**REQUEST FOR INFORMATION
FOR
COUNTY OF SAN MATEO**

**COYOTE POINT RECREATION AREA EASTERN PROMENADE REJUVENATION
PROJECT**

**COUNTY PROJECT NO. P30Y1
PROJECT FILE NO. E4948 (Project)**

**THE COUNTY OF SAN MATEO DEPARTMENT OF PUBLIC WORKS
HAS PROVIDED RESPONSES (R) TO THE QUESTIONS BELOW**

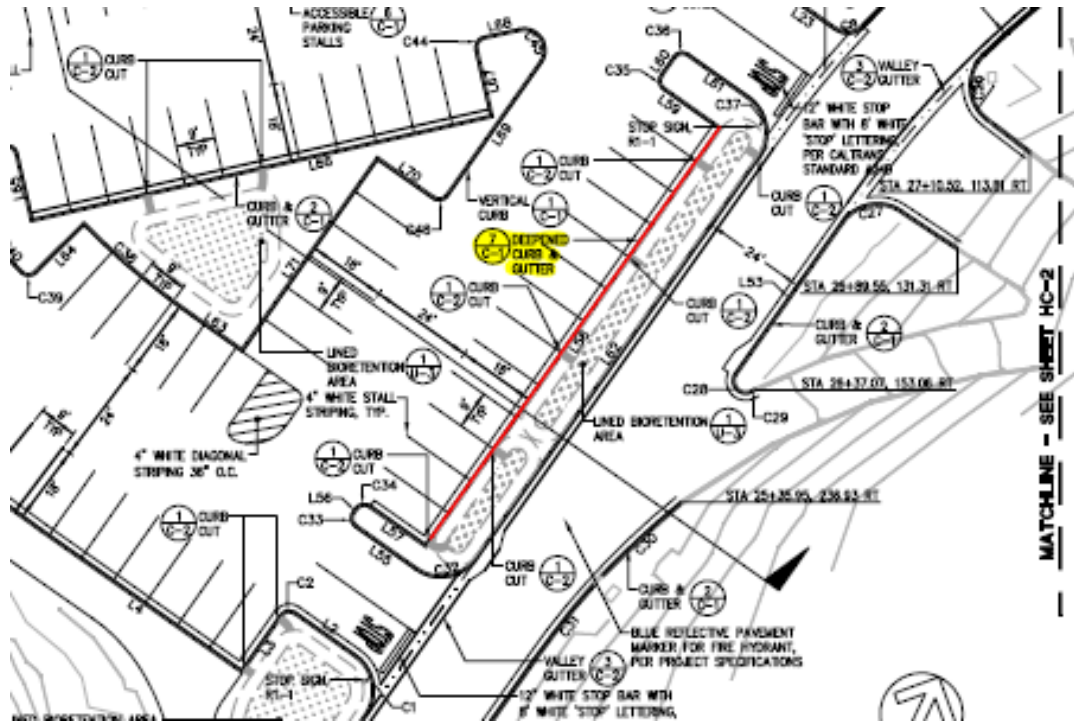
Q-16. Entry Sign – Could you please provide some detail for the sign so we have a rough idea of what we are installing. Is it a concrete sign with a concrete base? Is it a metal/wood sign with one or two posts wood/metal posts?

R-16. Entry sign shall match the other entry signs within the Coyote Point Park. Entry sign shall be similar to the western promenade sign shown below.

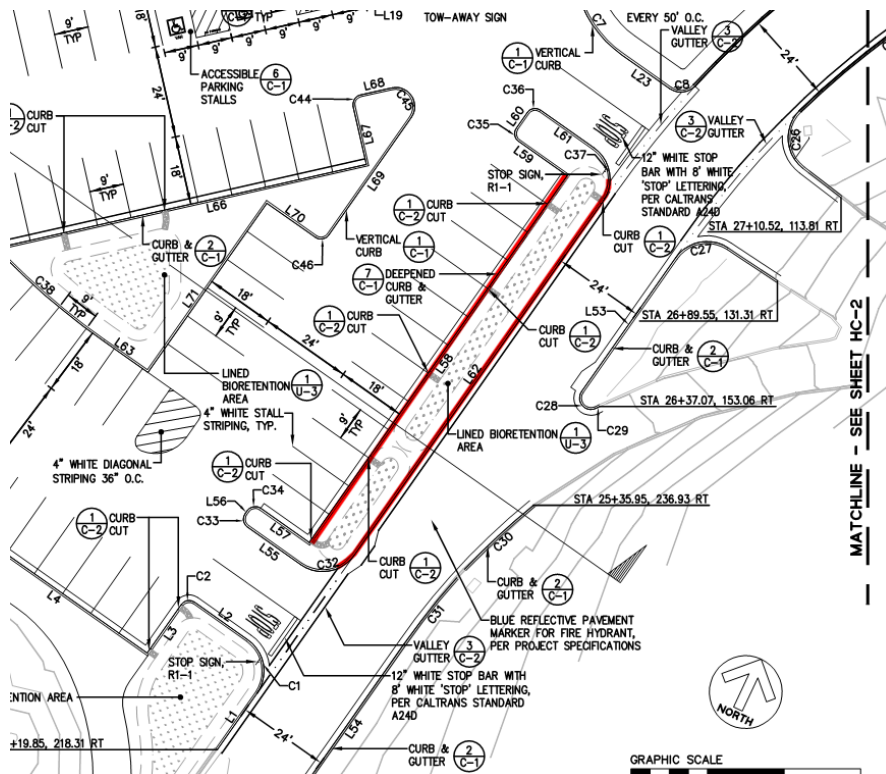
Q-17. Deepened Curb and Gutter (located on Sheet HC-1) – are the curbs highlighted in red the only deepened curb and gutter locations (Detail 7 on Sheet C-1)?

R-17. Location of deepened curb and gutter highlighted in red below.

Excerpt from Sht U-1
MIG Comments shown in red.
1/12/21

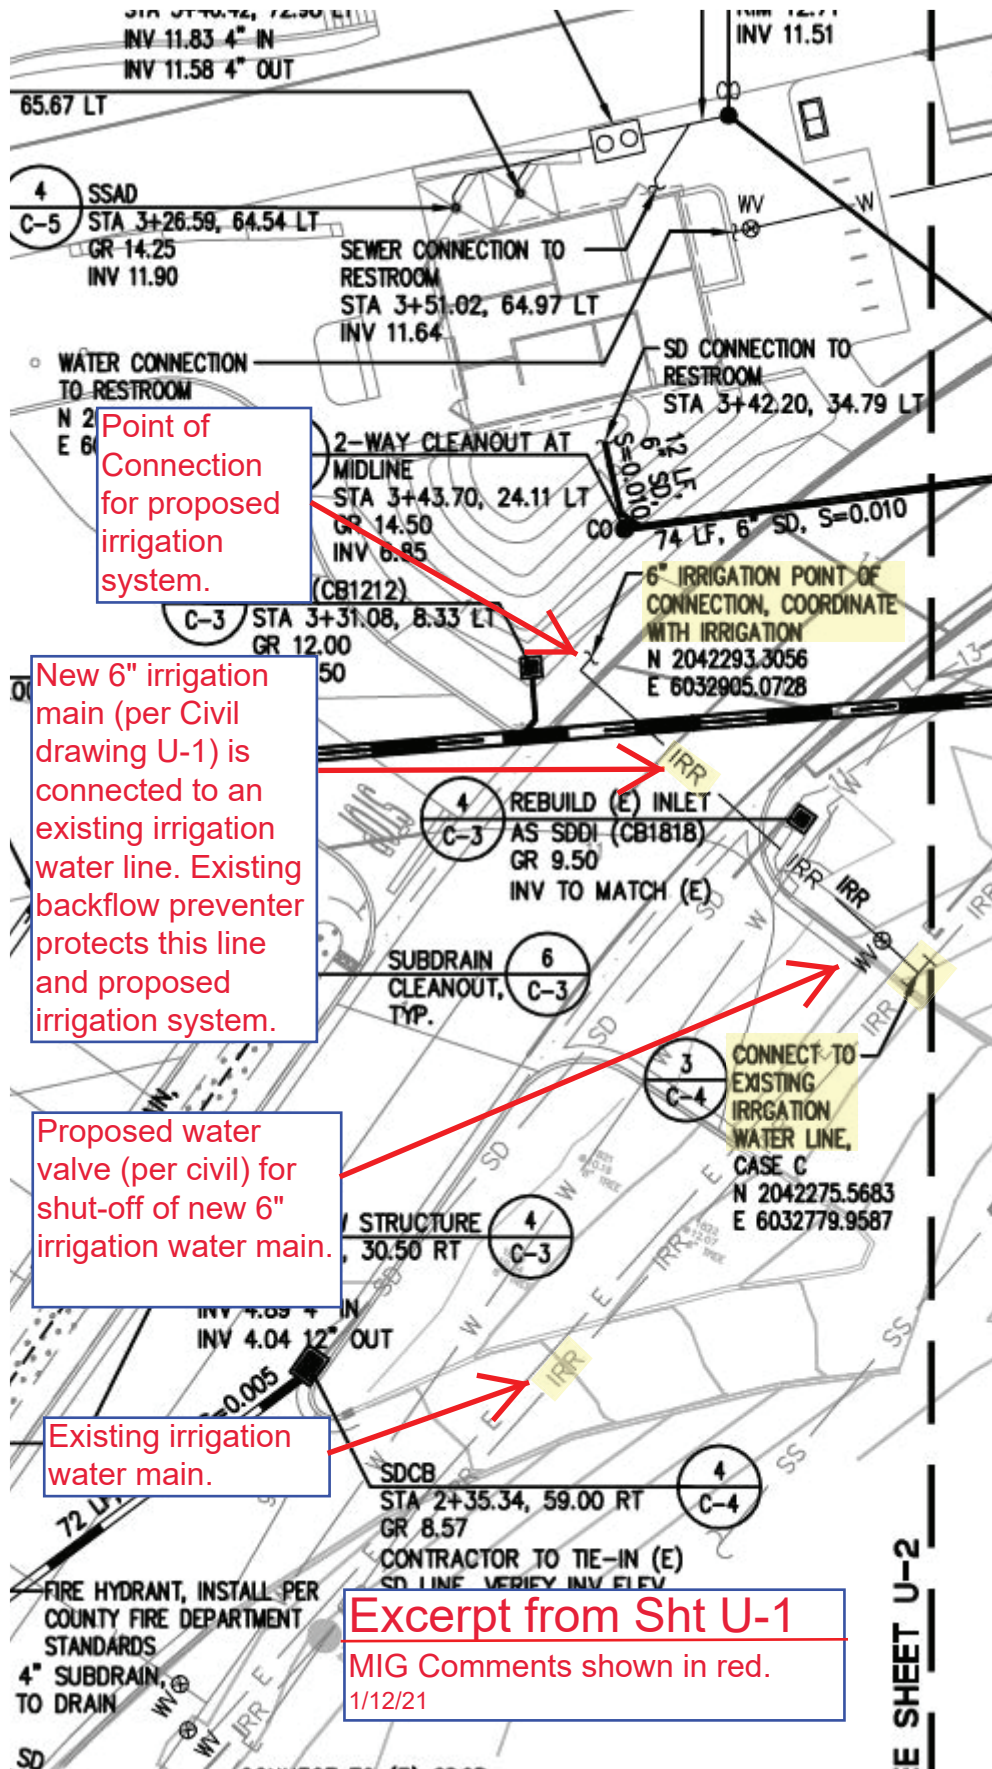
Q12-1. Is the 6" mainline live or dry?

Q12-2. Is there an existing backflow preventer? There isn't one called out in the plans.

R12-1. The attached sketch (Exhibit A - "Excerpt from U-1") shows the proposed Irrigation Point of Connection to an existing pressurized irrigation main.

R12-2. There are no existing backflow preventers located within the Project area. However, there are two existing backflow preventers for this water system within Coyote Point Park.

Point of Connection for proposed irrigation system.

New 6" irrigation main (per Civil drawing U-1) is connected to an existing irrigation water line. Existing backflow preventer protects this line and proposed irrigation system.

Proposed water valve (per civil) for shut-off of new 6" irrigation water main.

Existing irrigation water main.

There are two existing backflow preventers within Coyote Point Park. One by the golf course parking lot and the other at Poplar Avenue.
